To: Users of SFI Specs 2.1
From: SFI Foundation, Inc.
Subject: Spec 2.1C, Revision, effective December 3, 2021

The above referenced SFI Specs for Rear Engine Dragster Roll Cage (Top Alcohol/Methanol) 5.99 Seconds and Quicker have been revised, effective December 3, 2021. The revised version is designated as SFI Specs 2.1C and is immediately available from SFI for use by sanctioning bodies and chassis builders.

Section II.8:

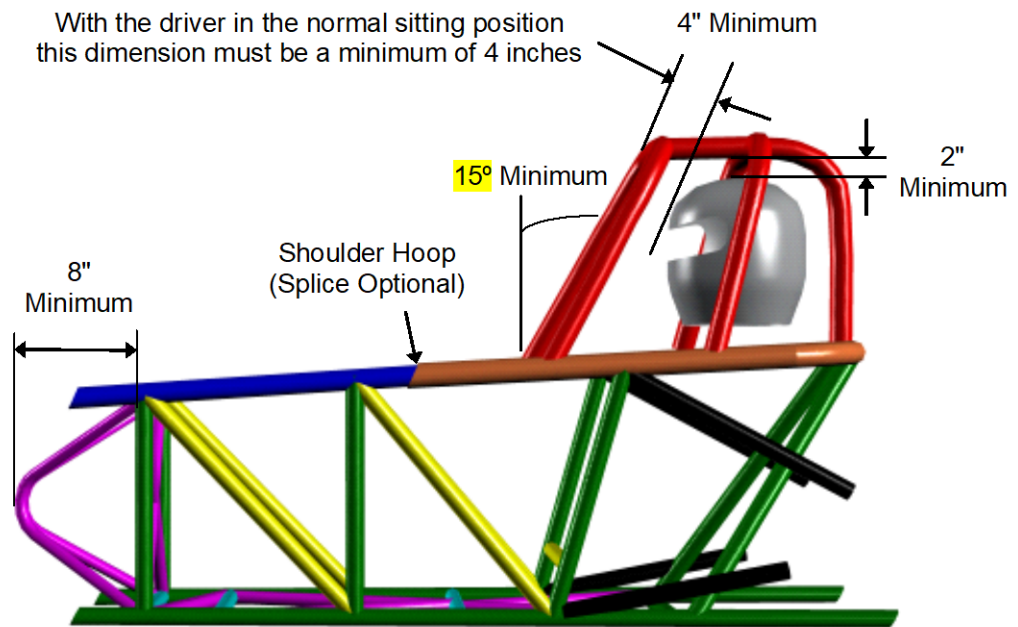
- Diagonals and "K" members can be oriented in any direction, unless otherwise specified. Example: left to right, top to bottom, forward to rear, etc. Side bay and floor diagonals, X-members, and K-members must intersect within three tubing diameters of the intersection of the upright or cross member and the frame rail **within the same plane** (measured edge-to-edge, using tube diameter of the diagonal, X, or K.).

3. REAR-END UPRIGHTS

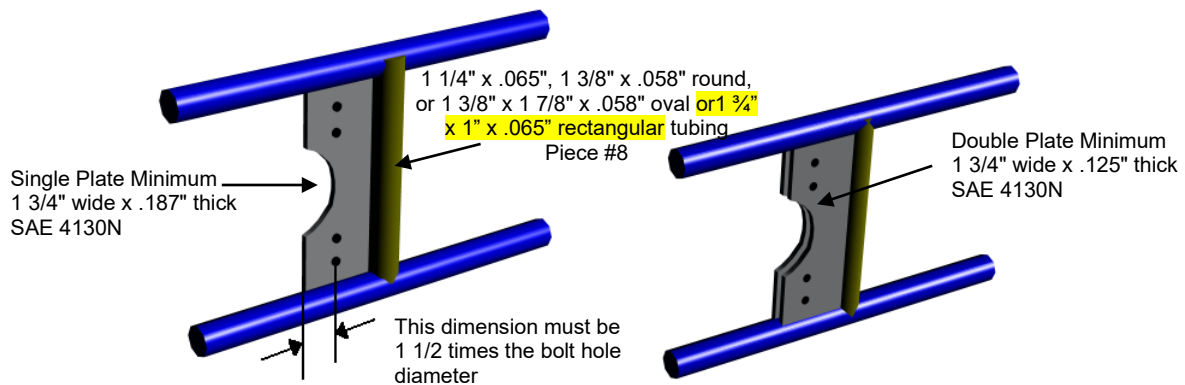
1 1/4" x .065", 1 3/8" x .058" round or 1 3/8" x 1 7/8" x .058" oval or 1 3/4" x 1" x .065" rectangular tubing on each side of the chassis with either one (1) 3/16" (4.7 mm) SAE 4130N steel plate per side (no bosses required) or two (2) 1/8" (3.2 mm) SAE 4130N steel plates per side with 3/4" (19 mm) minimum outside diameter bosses. Single plates must be fully welded to the rear end uprights (#8) and to the upper (#4) and lower (#16) frame rails on one side of each plate with 1/4" (6.4 mm) minimum wrap around the upper (#4) and lower (#16) frame rails. The other side can be welded with one (1) inch (25.4 mm) minimum skip welds. Double plates must be fully welded to the rear end uprights (#8) and to the upper (#4) and lower (#16) frame rails on one side of each plate with 1/4" (6.4 mm) minimum wrap around the upper (#4) and lower (#16) frame rails.
